Re: Addendum #1 to IFB 18-02, Main Street Municipal Parking Lot  
*Questions and Answers*

The City is issuing Addendum #1 to 18-IFB-002 to: Answer questions received about the bid.

**SITE DETAILS**

**PROPOSED PARKING FACILITY**

**CONCRETE WALK AT STREET CURB**

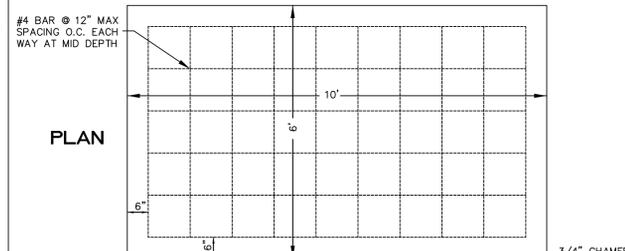
4. Please provide a section showing thicknesses of surface and base layers for the following items: parking lot paving, bus stop kiosk pad and concrete sidewalk/driveway apron if different from the scored concrete section.

A revised Site Detail Sheet, Sheet 9 of 9, revised August 23, 2017, has been attached which clarifies the thicknesses of surface and base layers for parking lot pavement, bus kiosk pad, and concrete sidewalks and driveway aprons.

**WALKWAY SCORE AND BRICK PATTERN**

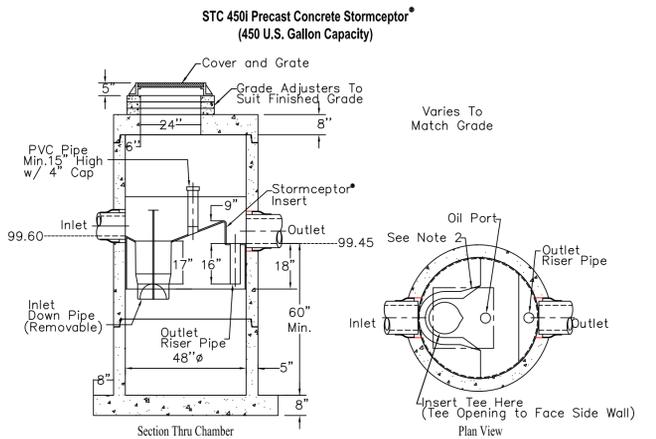
2. The "walkway score and brick pattern" detail calls out "5" concrete walk fiberglass reinforced." The specs in the concrete section do not call out any fiberglass reinforcement. Is fiberglass reinforcement supposed to be in the concrete mix for the scored concrete? If so, how much per CY?

8. The specifications do not include fiber reinforced concrete sidewalks.

***Answer: The applicable specification has been included under Changes to Project Manual on page 2 of this addenda***

- G. All cast in place concrete shall contain polypropylene fiber reinforcing with a fiber length of 0.75 inches minimum and mixed at a rate of 1.5 pounds per cubic yard of concrete.
